AGENDA – Planning Commission Meeting

CITY OF SARATOGA SPRINGS

Site Plan

Harvest Point Commercial Plat A Lot 2

EXHIBIT 5

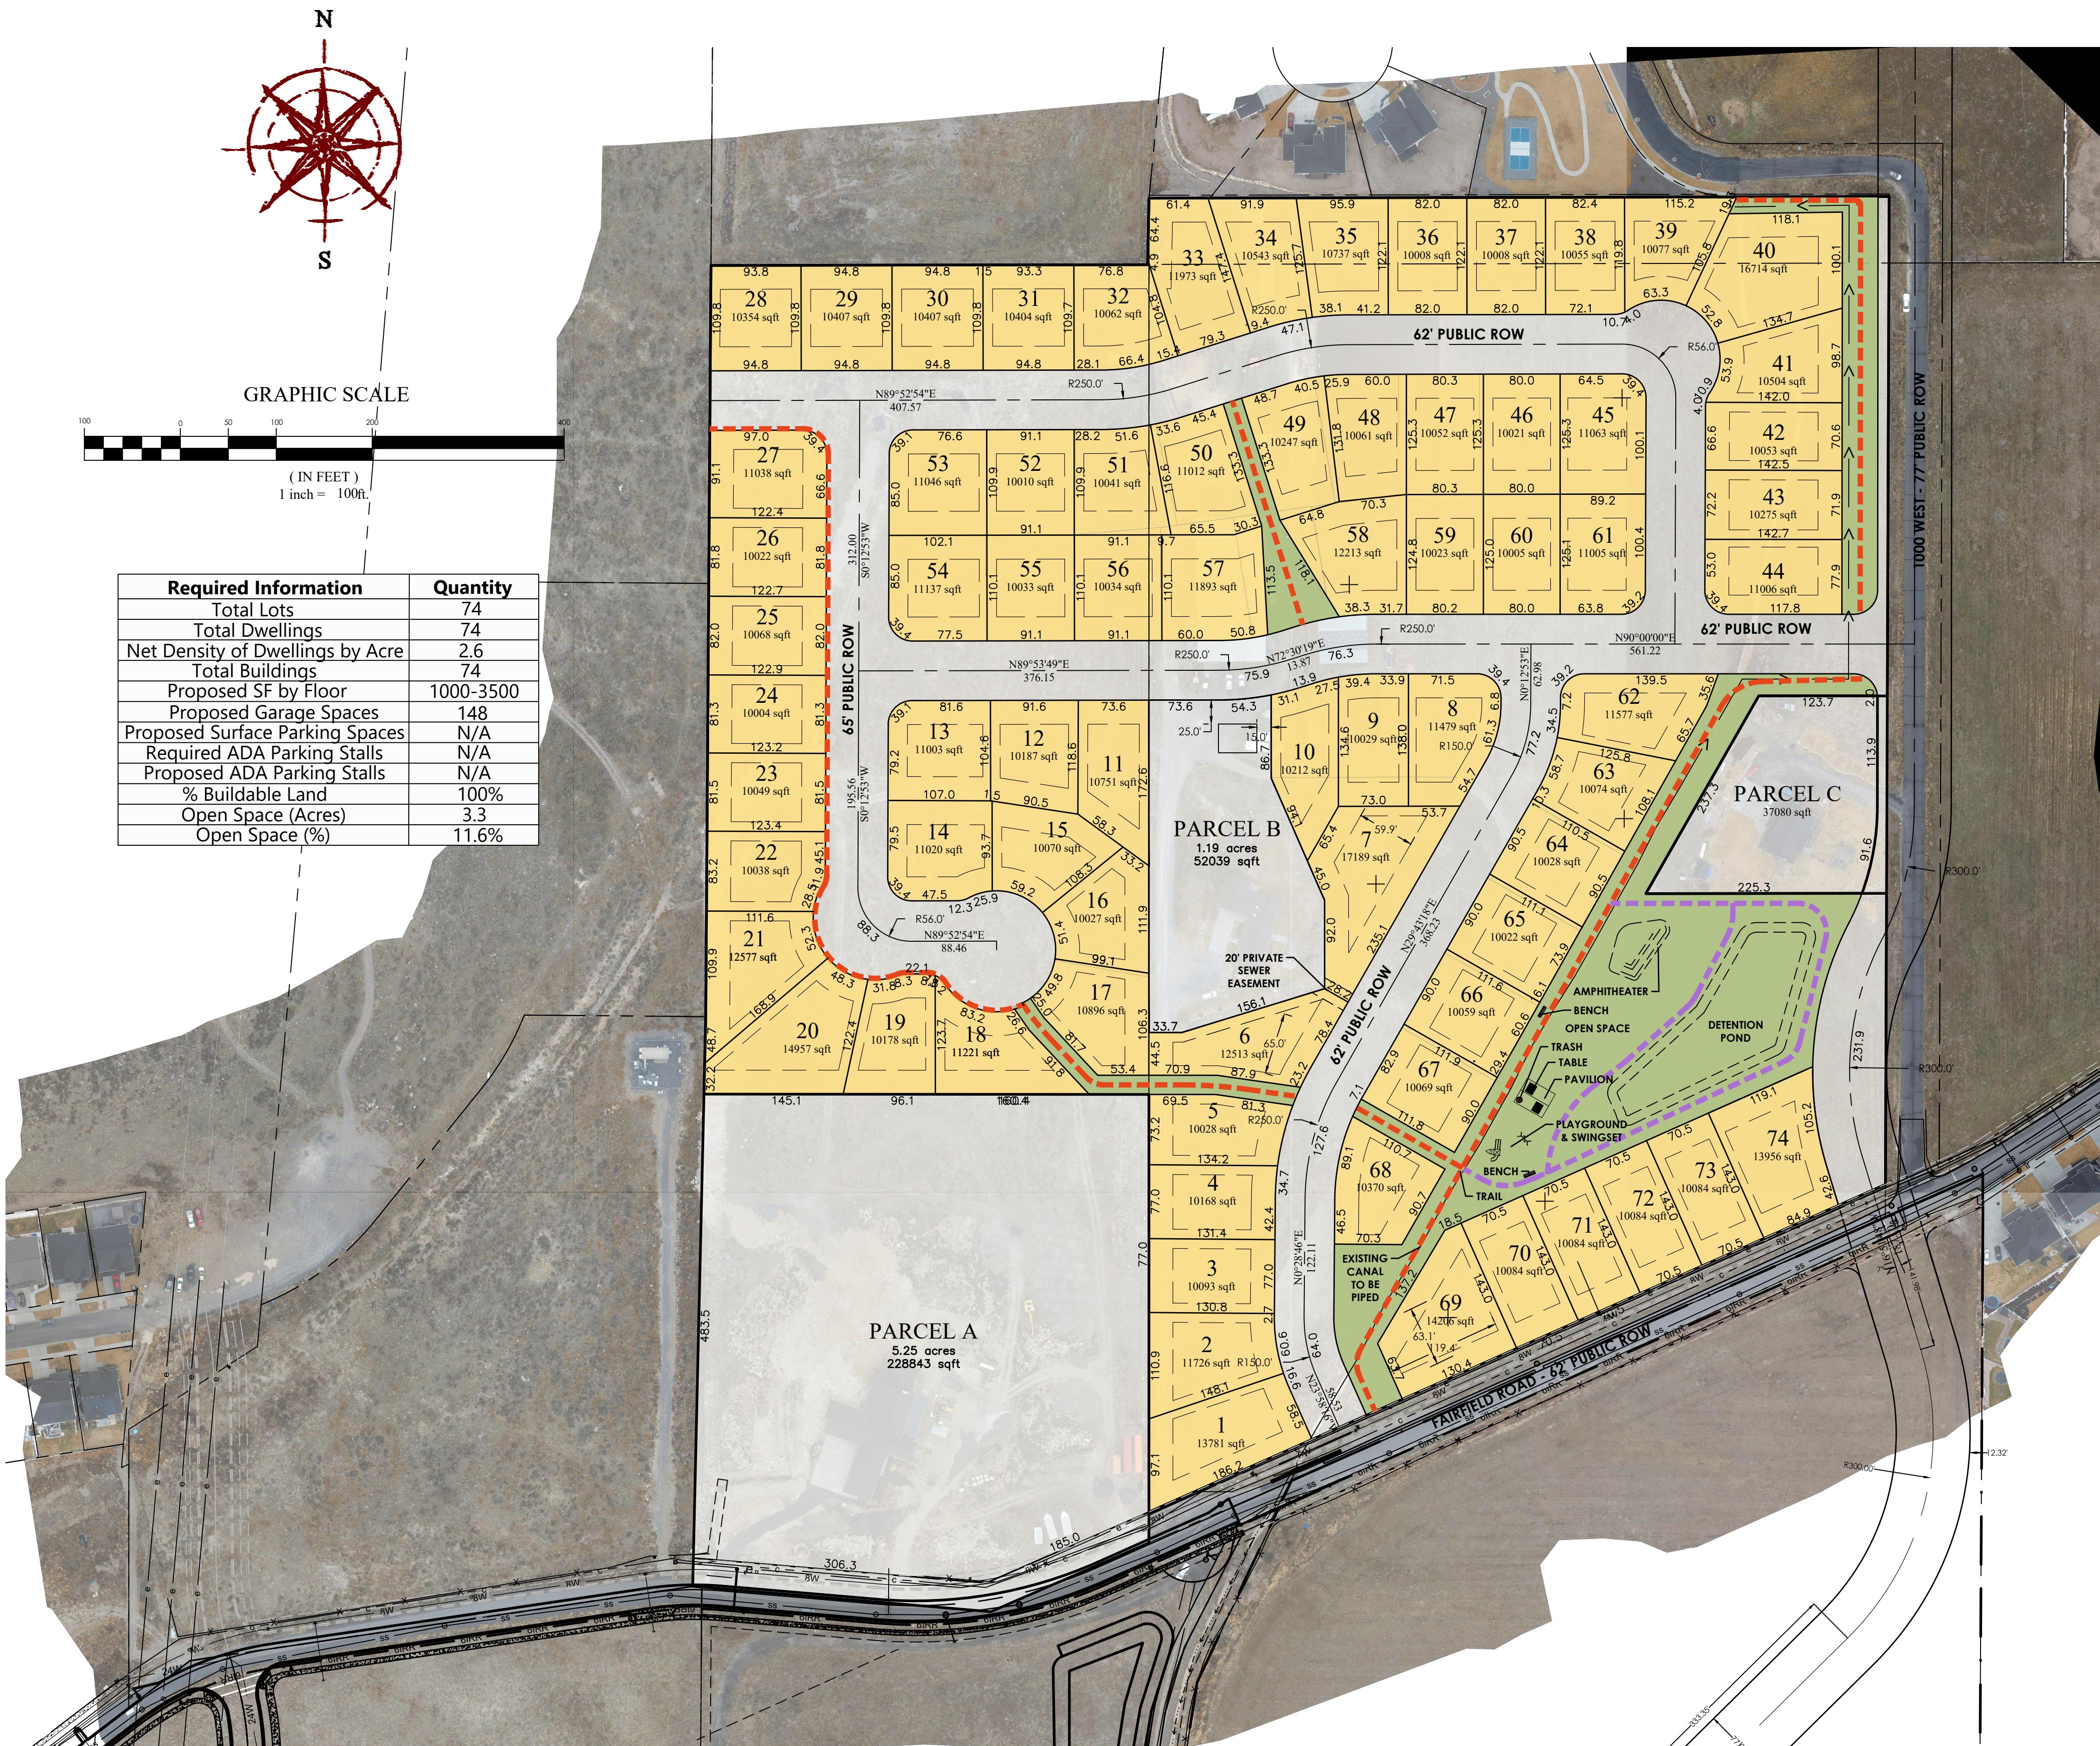
C. Recommendation: Staff recommends the applicant address and incorporate the following items into the development of their project and construction drawings.

1. The City has insufficient information at this time to determine what project and system improvements will be necessary to service the developer's property. As a result, this review does not reserve utility system capacity. Prior to, concurrent with, or subsequent to Final Plat Approval, the developer will be required to install all required infrastructure to service the property while mitigating negative impacts to the existing system. In addition to all required project improvements, the developer may also be required to install any and all system improvements, subject to required impact fee credits.
